Docket Item # 14
BAR CASE # 2017-00190

BAR Meeting
July 5, 2017

ISSUE: Alterations (Signs and Waiver of Rooftop HVAC Screening Requirement)

LOCATION: 1100 King Street

2 SOUTH HENRY ELEVATION
SCALE: 3/32" = 1'-0"

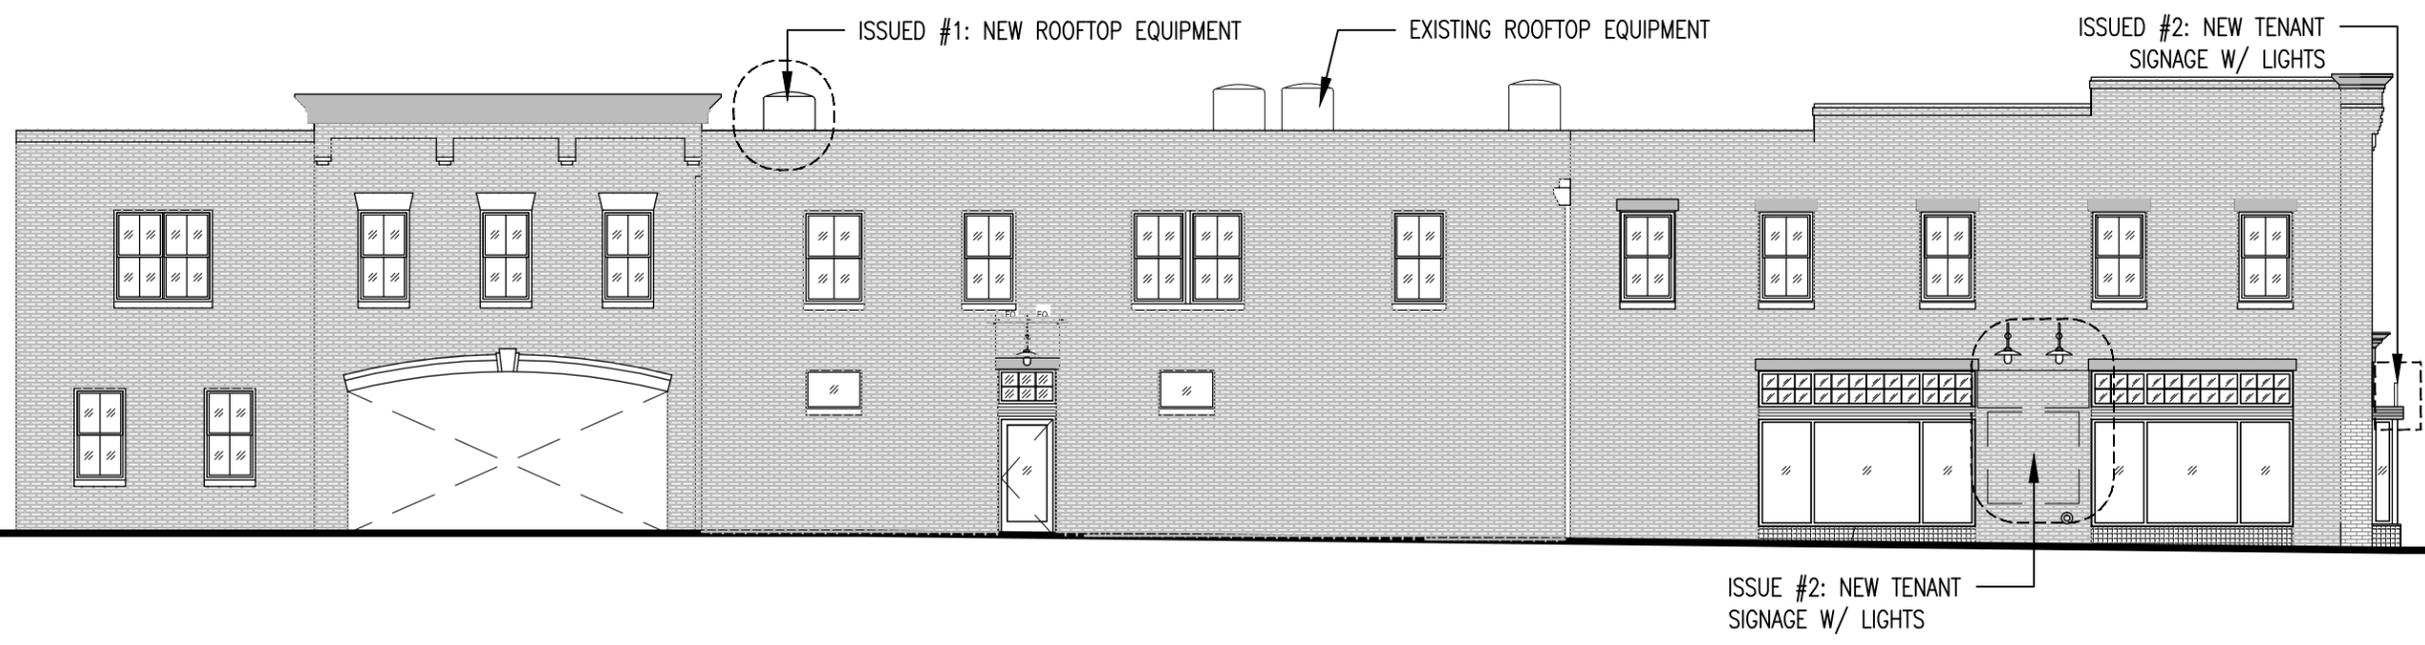
While the design, colors and wall location of the two wall signs on South Henry Street are also appropriate, staff suggests that the large size proposed (approximately 42 square feet) and the visual prominence of this elevation, would lend itself better to a painted wall sign, rather than the proposed aluminum and plastic, as the brick wall is already painted and the nostalgic design, colors and gooseneck lighting are ideal for a painted wall sign. Historic photographs of Old Town show many large painted signs on buildings as they were one of the most effective ways to promote a business and to also to integrate the sign with the building. Recently, at the corner of North Patrick Street and King Street, the BAR approved a painted wall sign for Blueprint Chocolatier which is quite successful. From a preservation perspective, a painted sign is also preferable as it is easily reversible and will not have any permanent impact on the brick. Staff is always concerned when wall signs are installed on brick walls that installers often overlook the importance of drilling into the mortar joints rather than directly into the historic brick. Therefore, staff strongly encourages that the wall signs on South Henry Street be painted brick.

1. That the proposed wall signs on the South Henry Street elevation be painted on the brick signs rather than wall-mounted signs; and
2. Either one hanging sign or one changeable-copy wall sign, each up to seven square feet, may be installed adjacent to the secondary entrance on South Henry Street.

1 CROSS SECTION – ROOFTOP EQUIPMENT VISIBILITY
SCALE: 3/32" = 1'-0"

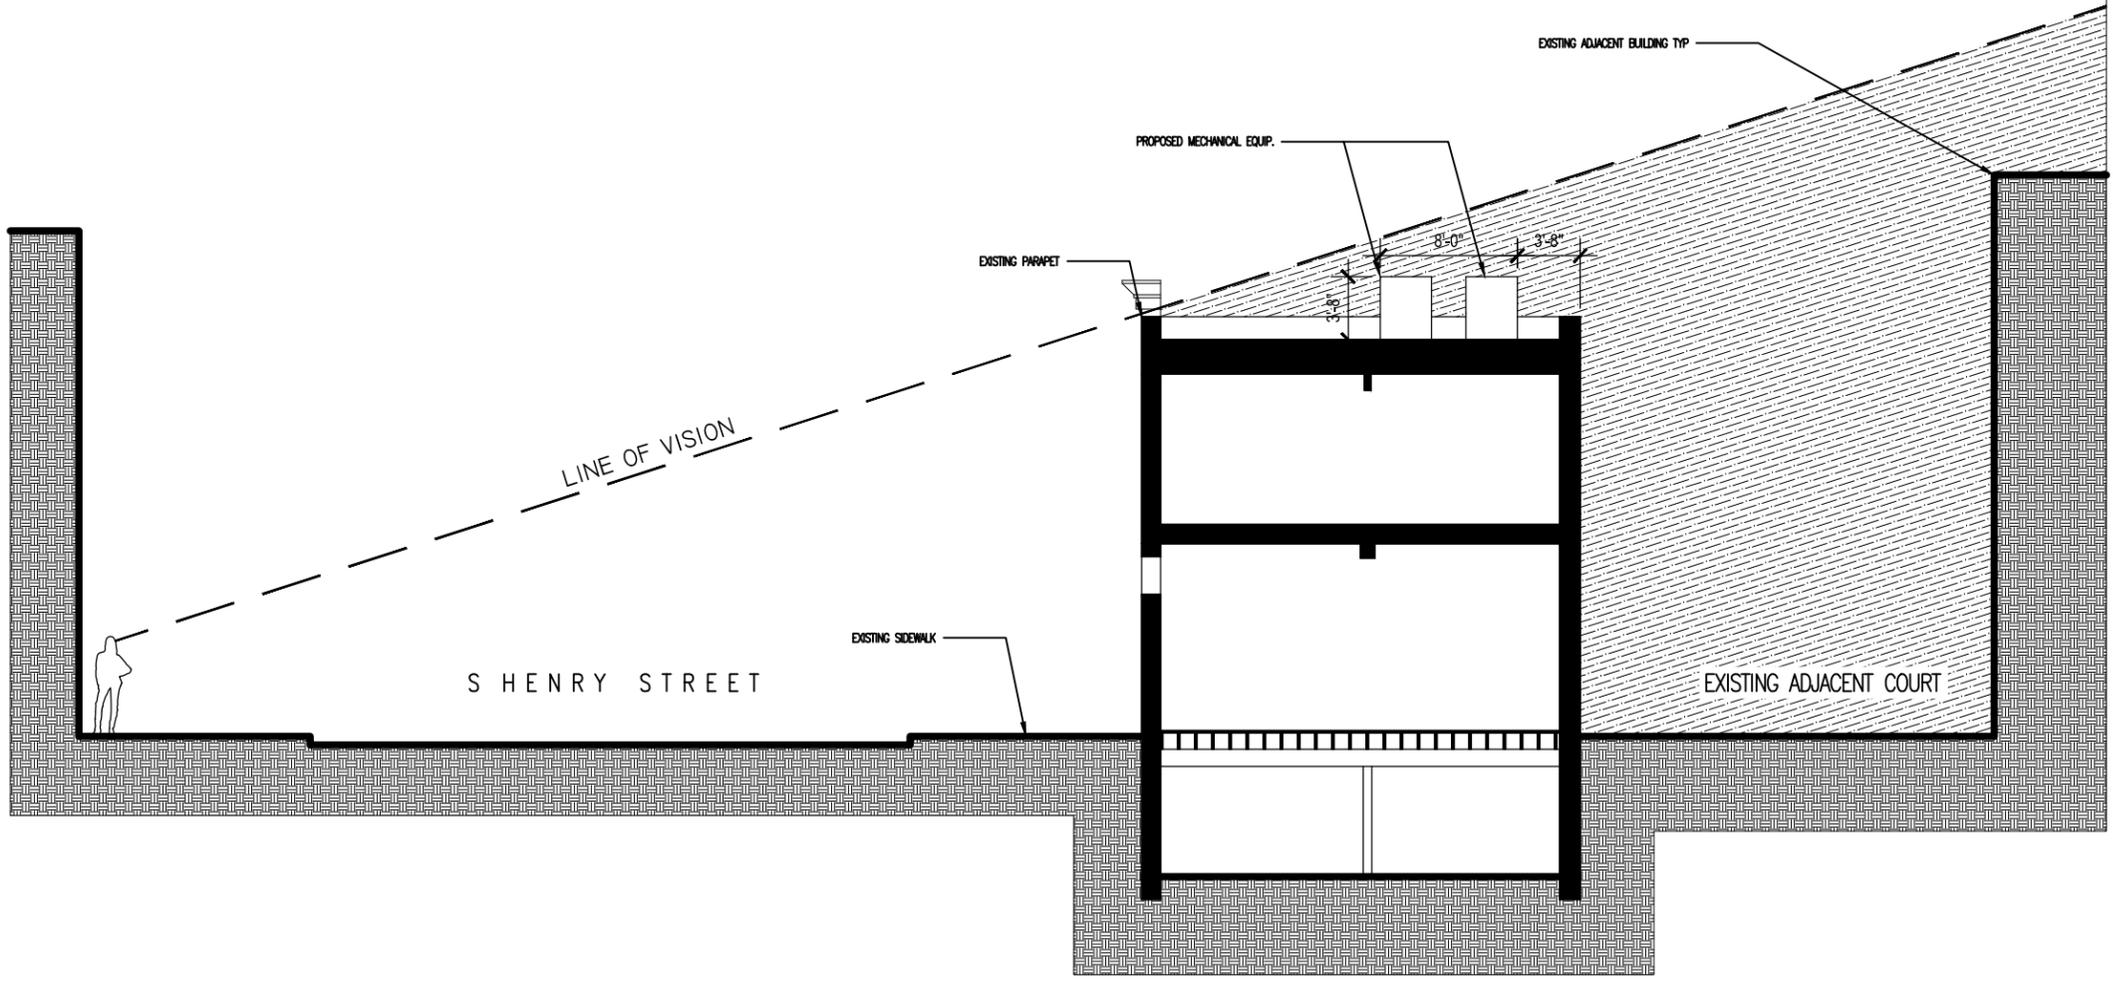
screened from. The BAR has, generally, considered the units to be functionally concealed if they were not visible from a pedestrian standing on the sidewalk across the street, though in some cases views from neighbor's upper floors was considered. Section 6-403(B)(3) of the zoning ordinance also permits the BAR to waive the screening requirement for rooftop mechanical equipment, should the BAR find that the screening itself would be more visually obtrusive than the units themselves, or if the screening would damage a historic structure. In this case, the applicant has provided sight lines indicating that there is existing rooftop mechanical equipment that is negligibly visible and illustrating that the additional units will be located on the roof so that they will also be barely discernible in this commercial area. Therefore, staff supports the request to waive screening requirement for the rooftop units.
